Marion St. Bridge

Project Description

Meeting Summary

August 2, 2018

Figure 2: Proposed design for transition ramp (left) and intersection with Colman Dock (right)

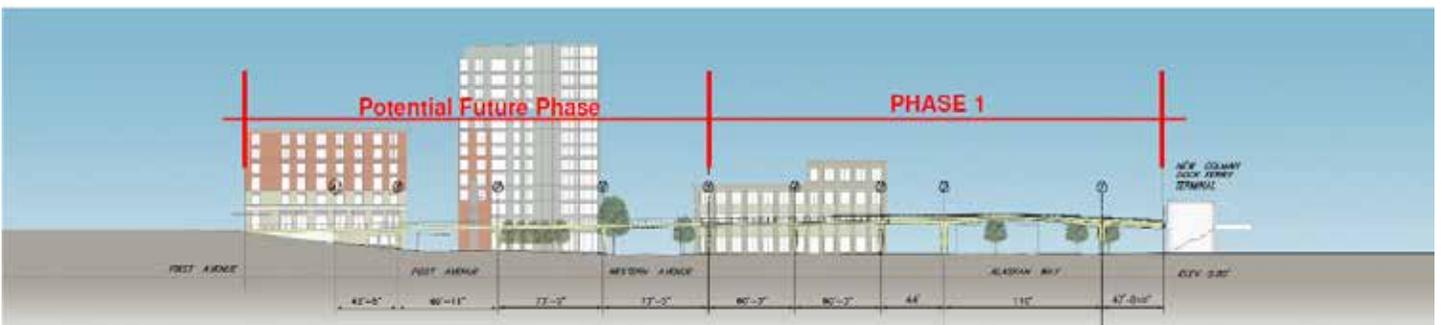
The discussion of the overall concept also included discussion about circulation, access, mobility, and the integration of the design with the surrounding Waterfront and Colman Dock projects. The SDC commented that it is difficult to understand how the bridge will integrate with both end points, at Colman Dock and 1st Ave. Commissioners hope this will be resolved once the design for Colman Dock ferry terminal is finalized. The SDC then recommended that the project team provide more details about how the design and materials used will provide a transition where the bridge intersects with the Colman Dock ferry terminal. The Commission is concerned that the increased width of the proposed pedestrian pathway, where the bridge intersects with 1st Ave and Marion St., will restrict pedestrian flow along Marion St. and recommended the project team provide a design strategy to address potential circulation issues

The Commission also acknowledged the lack of vertical circulation and recommended the project team explore ways to provide additional vertical circulation elements. Commissioners then commended the project team for coordinating with adjacent private development to provide additional circulation – stair and elevator – but also recommended the project team provide an alternative plan if coordination with adjacent development cannot occur. The SDC then discussed project wayfinding. The Commission is concerned with the lack of wayfinding along the bridge and ferry terminal building and strongly recommended that circulation pathways as well as stair and elevator access within Colman Dock be clearly marked.

4. Encourage all pathways entering/exiting the bridge as well as stair and elevator access within Colman Dock be clearly marked.
5. Reevaluate the approach to better integrate the V structure into the overall column design, focusing especially on the approach span columns.

11. Explore design solutions for potential circulation issues where the bridge intersects with 1st Ave and Marion St.
